PROPOSED

**CALIFORNIA EVAPORATIVE EMISSION STANDARDS AND TEST PROCEDURES
FOR 2001 AND SUBSEQUENT MODEL MOTOR VEHICLES**

15-Day Notice version, released 4/15/99
Supplemental Comment Deadline: 4/30/99
Board Hearing: 11/5/98

Figure 2: Test Procedure for 2001 and Subsequent Model Motor Vehicles

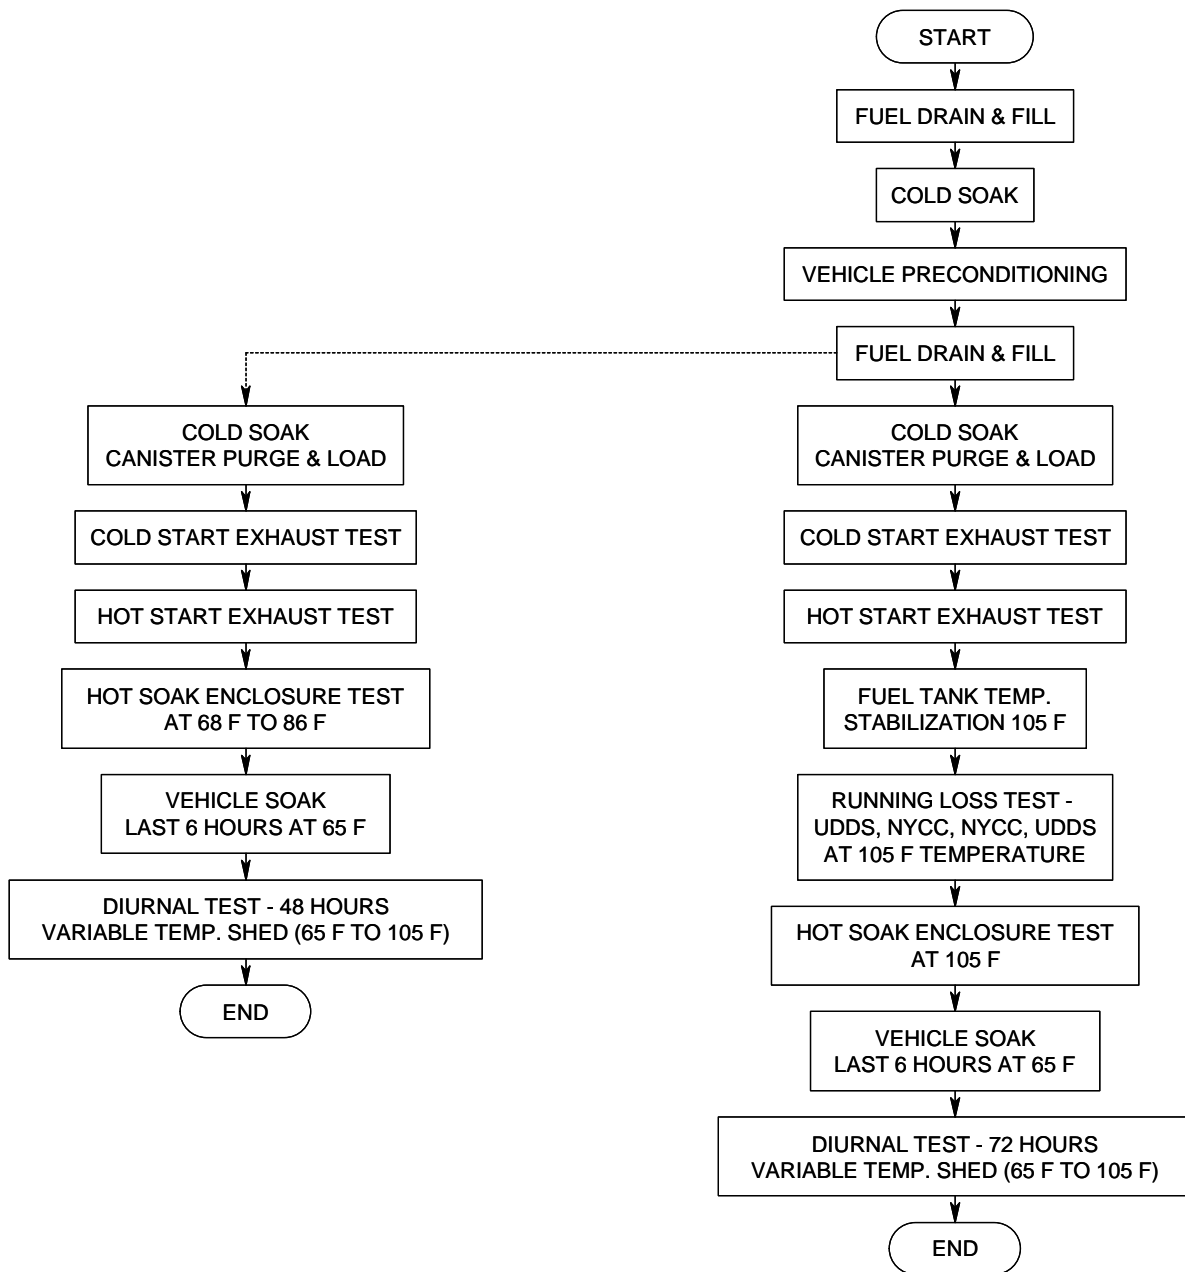
The three-day diurnal test sequence shown in Figure 2 (and Figure 3A or B for hybrid electric vehicles) is briefly described as follows:

The supplemental two-day diurnal sequence in Figure 4 2 (and Figure 5 3A or 3B for hybrid electric vehicles) shall be conducted according to the steps described in ~~(A)~~ 1.1 through ~~(D)~~ 1.4, ~~(F)~~, ~~(G)~~ 1.6, 1.7, followed by ~~(J)~~ 1.10 through ~~(L)~~ 1.12 of this paragraph except that the ambient temperature of the hot soak test is conducted at an ambient temperature between 68°F and 86°F at all times and that the diurnal test will consist of a two-day test.

Figure 3A: Test Procedure for 2001 and Subsequent Model Hybrid Electric Vehicles

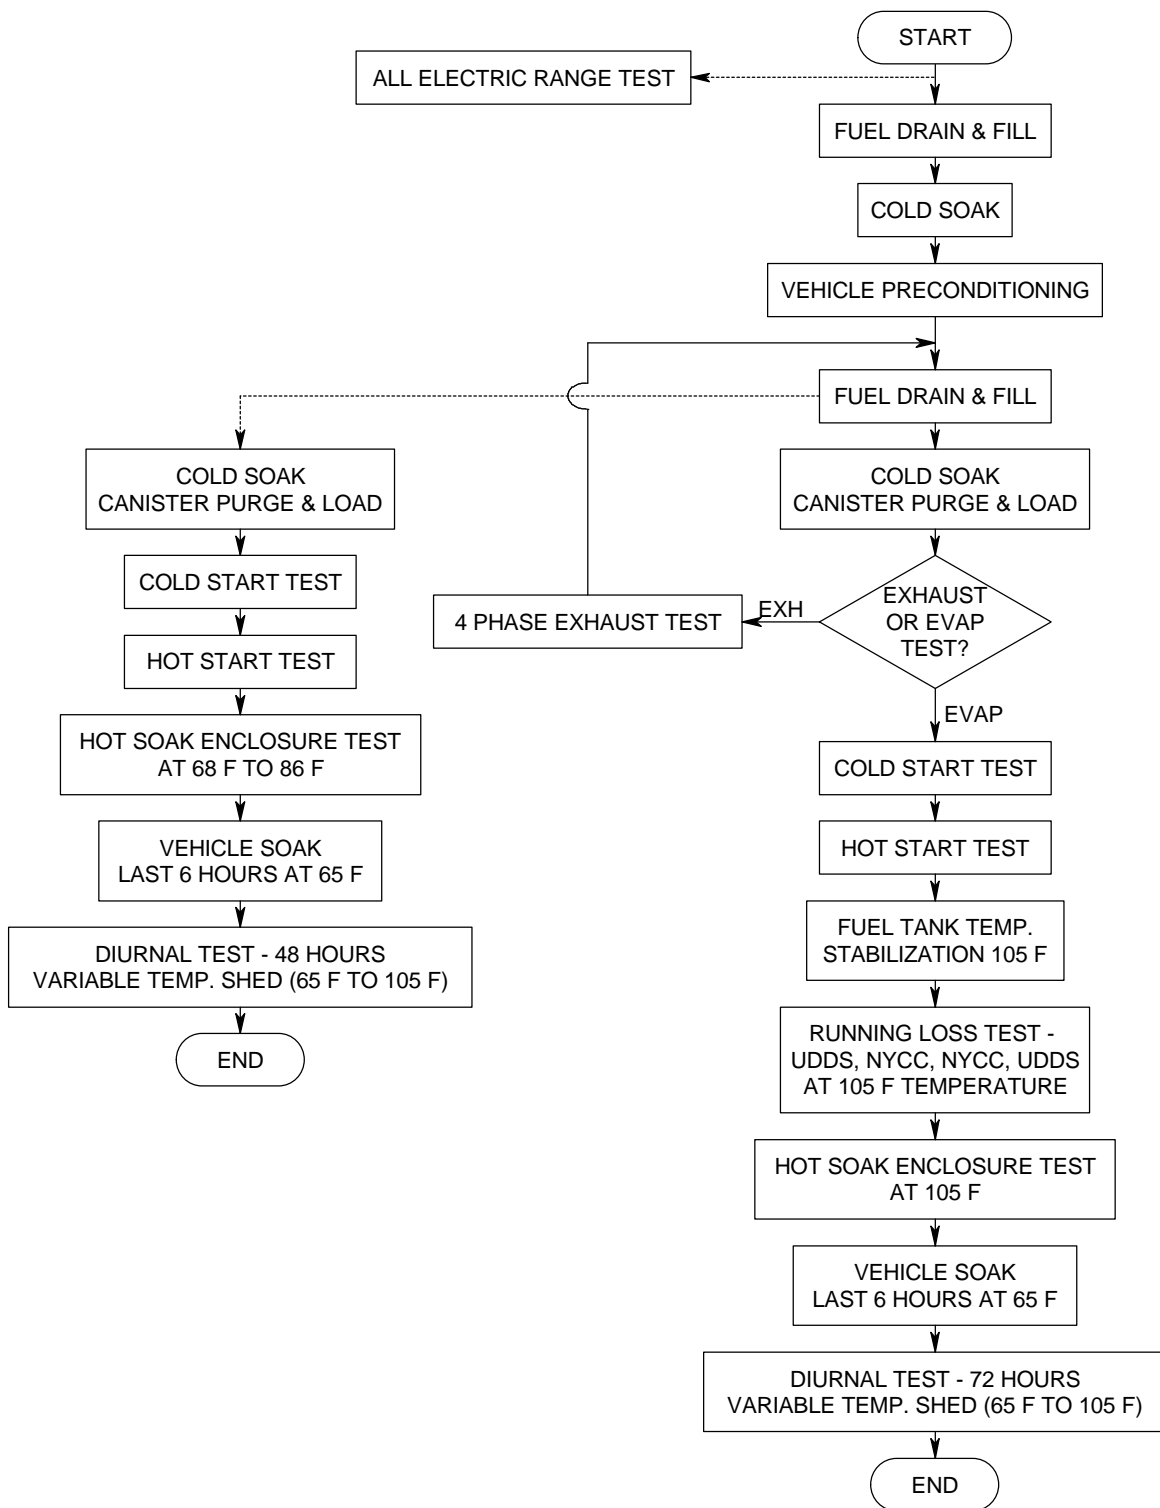
1.7.1 For hybrid electric vehicles, a four phase exhaust test shall be performed as shown in Figure 3A pursuant to the "California Exhaust Emission Standards and Test Procedures for 2003 and Subsequent Model Zero-Emission Vehicles, and 2001 and Subsequent Model Hybrid Electric Vehicles, in the Passenger Car, Light-Duty Truck, and Medium-Duty Vehicle Classes" as incorporated by reference in §1962(e), title 13, CCR. Following the four phase exhaust test, the test sequence shall repeat from step 1.3 of this section to conduct the evaporative test using the standard cold start test and hot start test (standard three phase test) without emission sampling. Battery state-of-charge setting prior to the standard three phase test shall be performed pursuant to section 6.1.6 of the "California Exhaust Emission Standards and Test Procedures for 2003 and Subsequent Model Zero-Emission Vehicles, and 2001 and Subsequent Model Hybrid Electric Vehicles, in the Passenger Car, Light-Duty Truck, and Medium-Duty Vehicle Classes" as incorporated by reference in §1962(e), title 13, CCR. Four phase exhaust testing may be performed in conjunction with evaporative testing as shown in Figure 3B with advance Executive Officer approval if the manufacturer is able to provide data demonstrating compliance with evaporative emission standards using the standard three phase test.
